Mid-America Group and NW77 JV Partnership - 3930 SE 72nd Avenue

ZON2006-00178

By same motion and vote, members moved for **APPROVAL** of a request for rezoning of subject property from the "A-1" Agricultural District it will automatically receive upon annexation, to "PUD" Planned Unit Development District along with a Conceptual Plan entitled "Harvest Hills" to include development of approximately 217 acres of agricultural land for 37.8 acres of general retail and highway oriented commercial development, 37.7 acres of medium-density multiple-family residential development, 61.3 acres of 70' wide lot single-family residential development, 21.4 acres of 60' wide lot single-family residential development, 40.5 acres of 50' wide lot single-family residential development, and 13.7 acres for school use with the following revisions: (ZON2006-00178)

HARVEST HILLS

TYPICAL LOT LAYOUTS

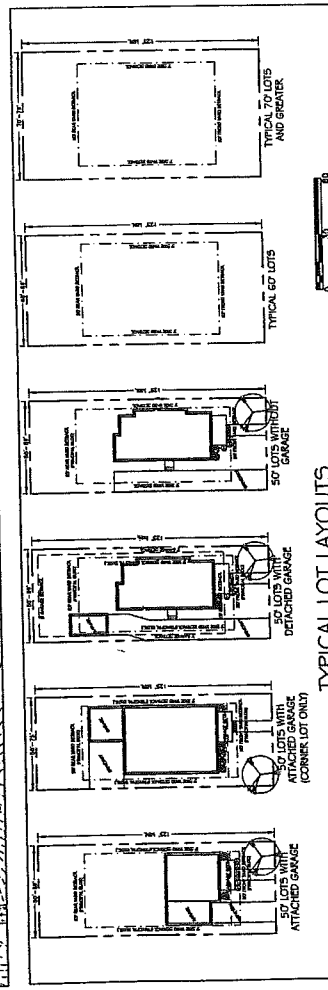
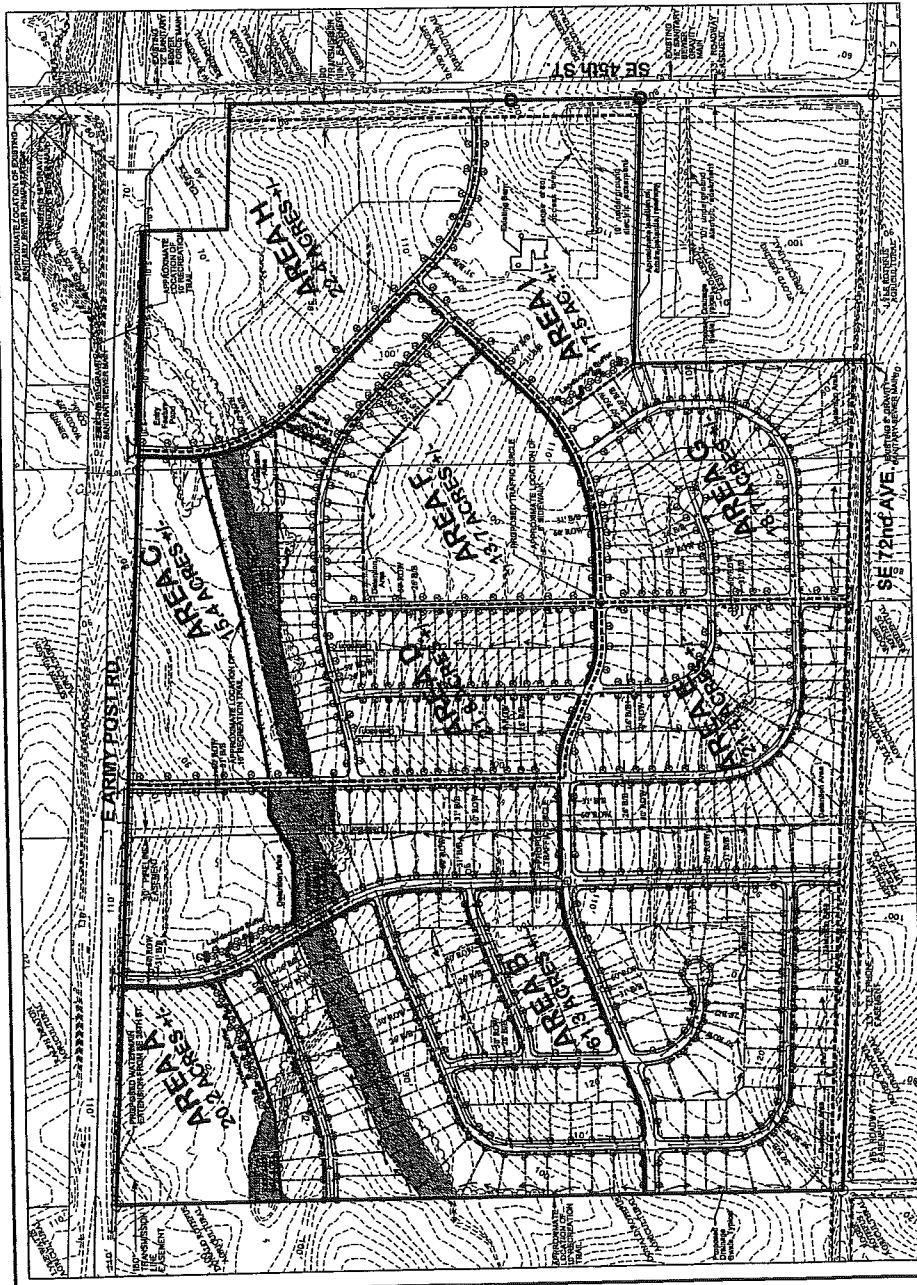
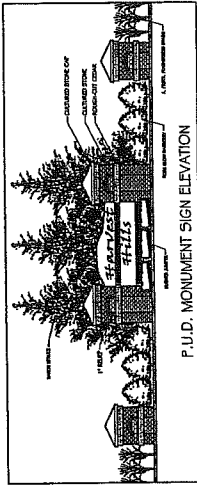
5. Modification of all 50' wide single-family lot requirements on sheet to "require" a detached or attached 1-car garage and delete the typical lot layout on Sheet 2 that does not show a garage.
